# LOWER MINNESOTA RIVER WATERSHED DISTRICT

Lower Minnesota River Watershed District Board of Managers Meeting  
Wednesday, August 19, 2020

**Re:** Freeway Landfill and Dump Remediation – Project Update (Permit No. 2020-105)

**Re:** Fort Snelling Redevelopment Permit Review (LMRWD No. 2020-113)

# Figure 1: Freeway Landfill and Dump Preliminary Review, City of Burnsville, MN 09-June-2020

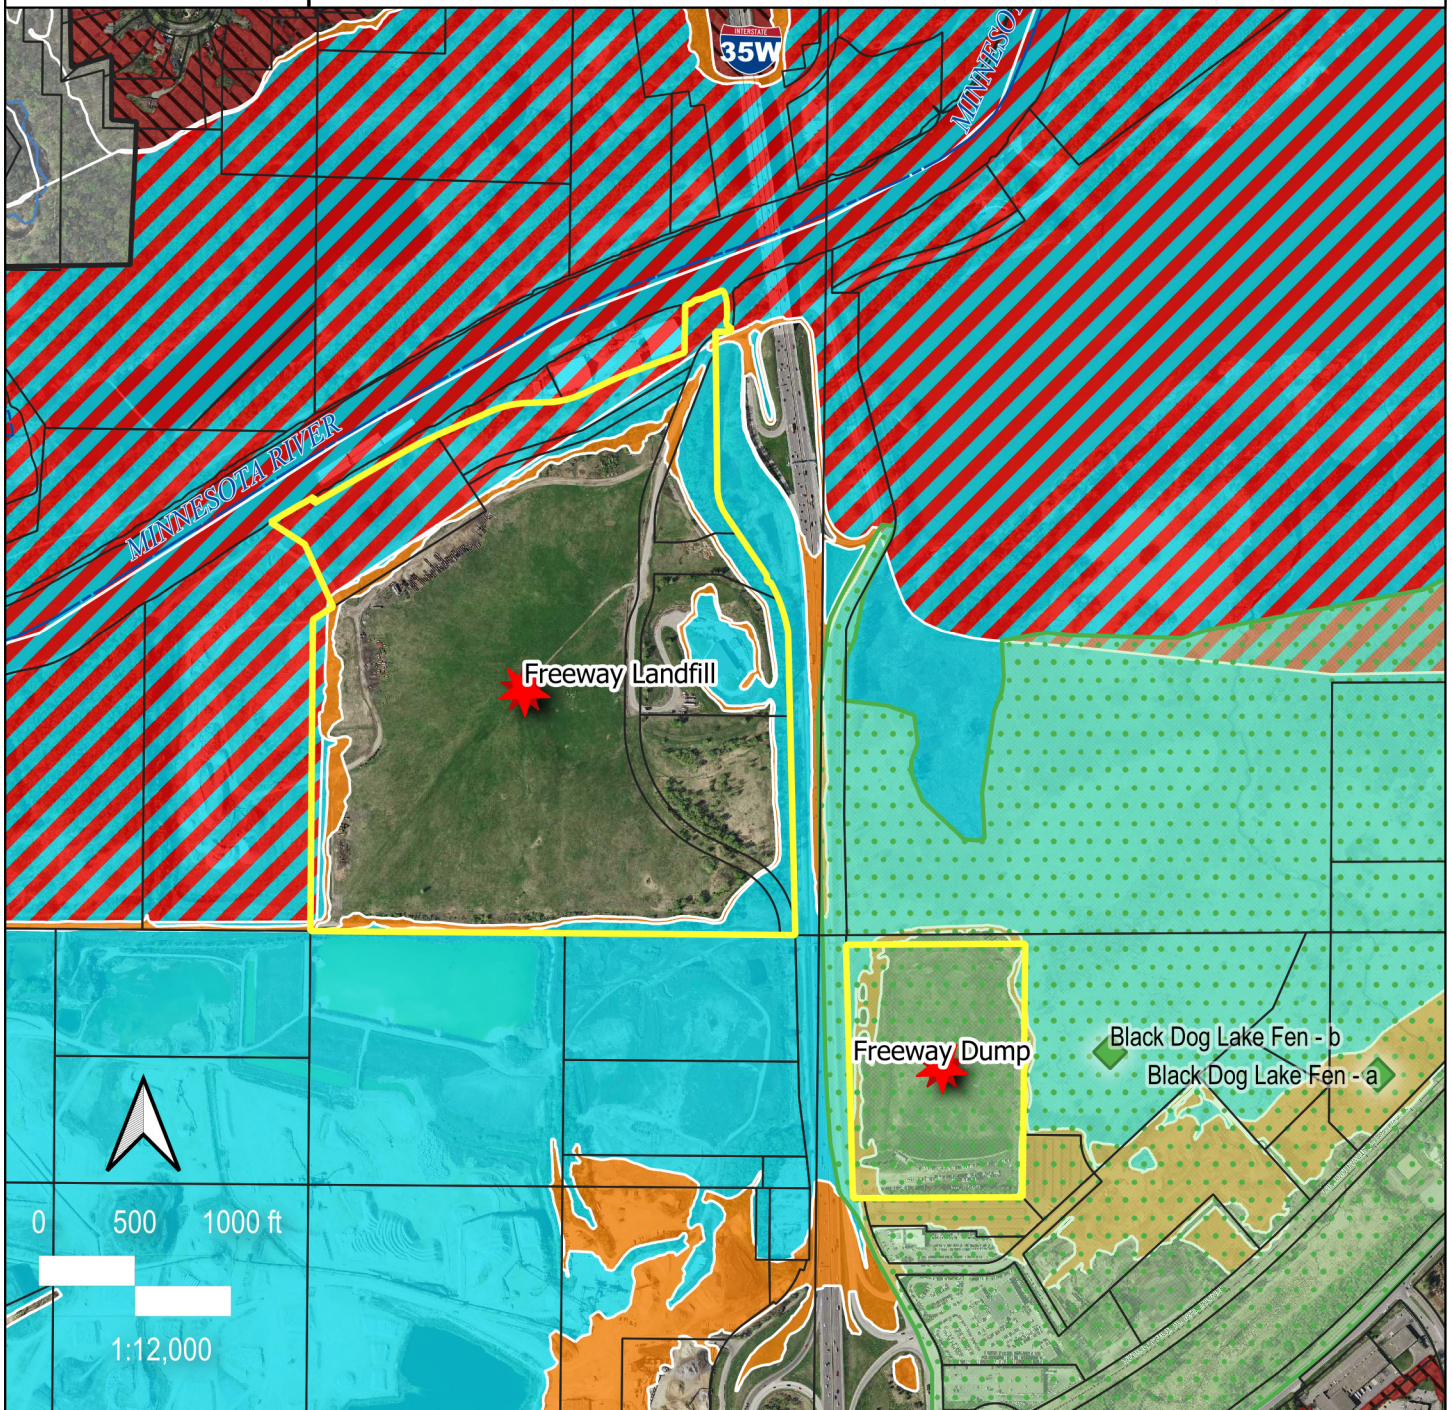
Based on the preliminary information provided, the proposed grading at the Freeway Dump site appears acceptable. However, it should be noted that the proposed grading will discharge into the Black Dog Lake Fen complex (**Figure 1**), and care should be taken during final design to ensure no adverse impacts would result to the fen from any concentrated stormwater runoff or outfalls.

Under Option 1 (Dig and Line), the project proposes to line and cover the landfill waste with an impervious liner under the waste and an impervious cap on top of the waste (Figure 1). Installing an impervious cover, even with roughly two feet of pervious cover vegetation and topsoil on top, may increase the amount of stormwater runoff generated from the landfill site, particularly with the proposed height and slopes of the final landfill. If Option 1 is selected as the final design, the District will require hydrologic calculations to demonstrate that the proposed stormwater runoff rates from the site do not exceed the existing rates.

- The Freeway Dump portion of the project is located within the High Value Resource Area for Black Dog Lake Fen, and care should be taken during design to avoid concentrated stormwater discharges into the fen during and after construction.

# Figure 1: Prairie Heights Preliminary Review

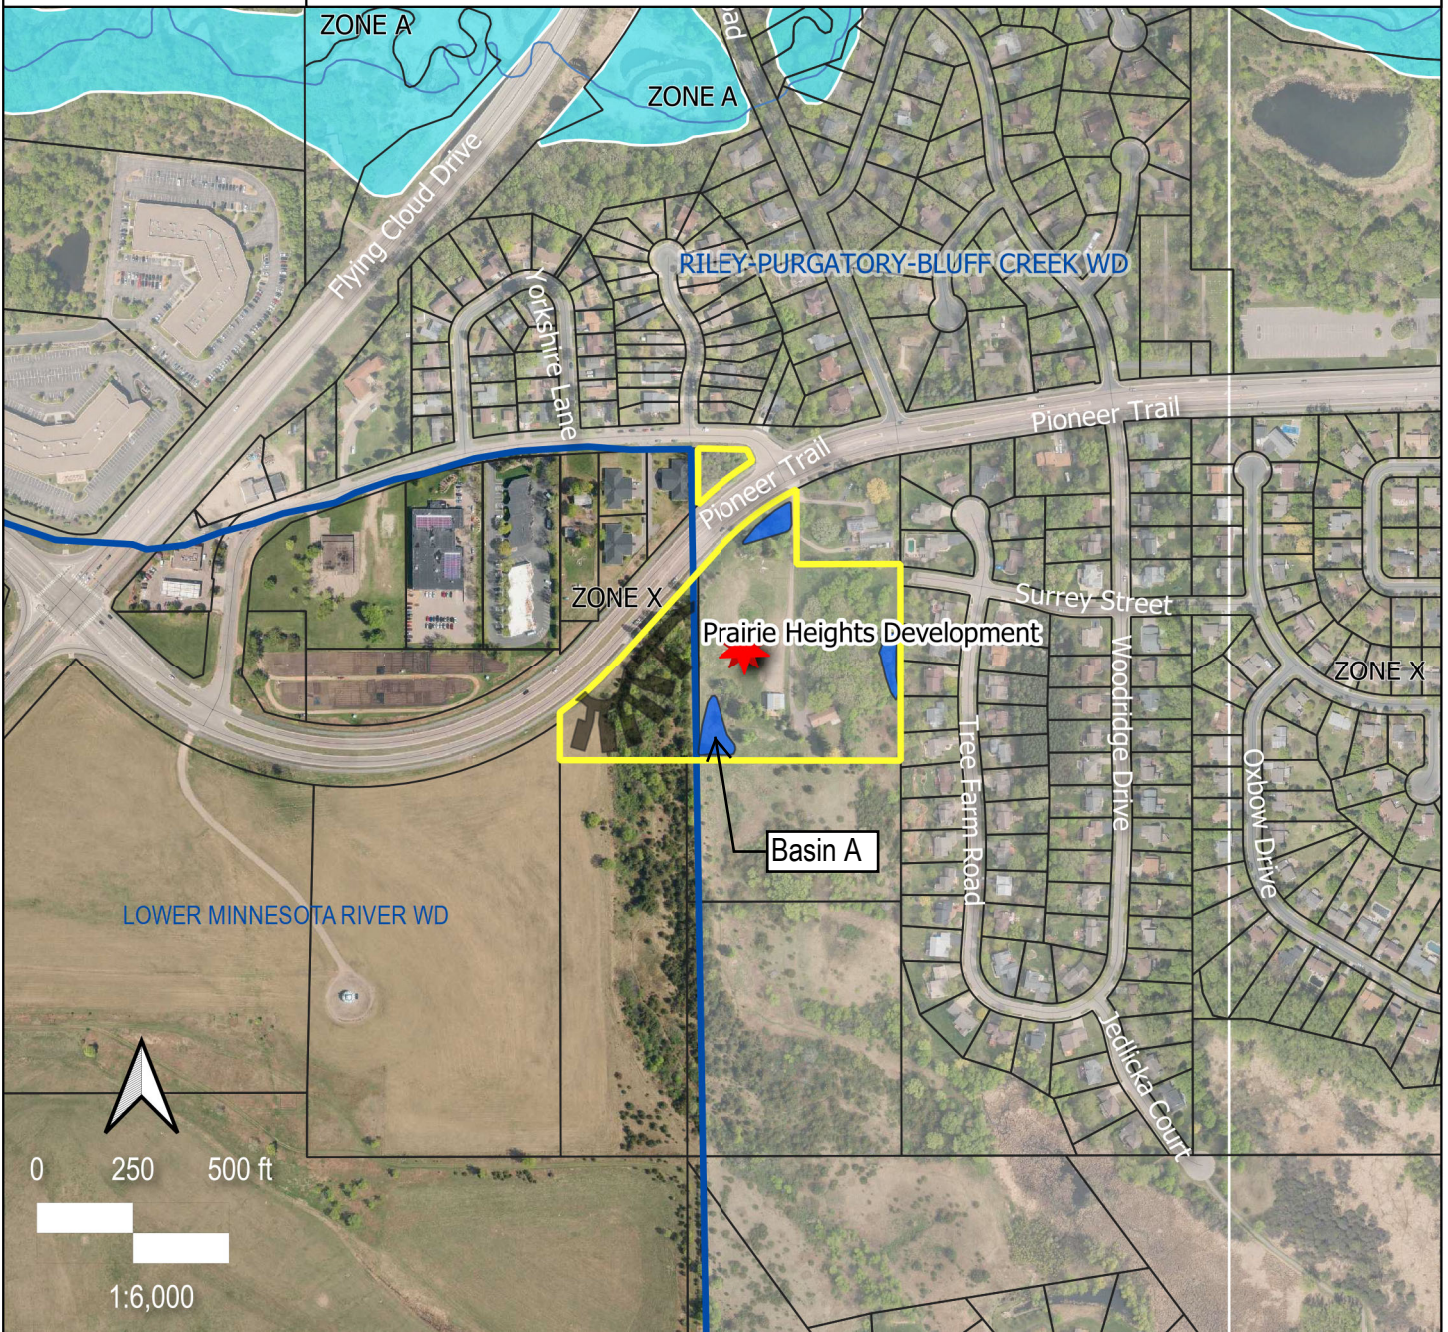
The Prairie Heights project spans the boundary between the District and the Riley-Purgatory-Bluff Creek Watershed District (RPBCWD). The extension of Surrey Street and construction of six single-family homes comprise the extent of the proposed improvements within the District. The portion of the Prairie Heights project within the District flows into RPBCWD under both existing and proposed conditions, and all proposed stormwater best management practices (BMPs) are located within the RPBCWD boundary ([Figure 1](#)).
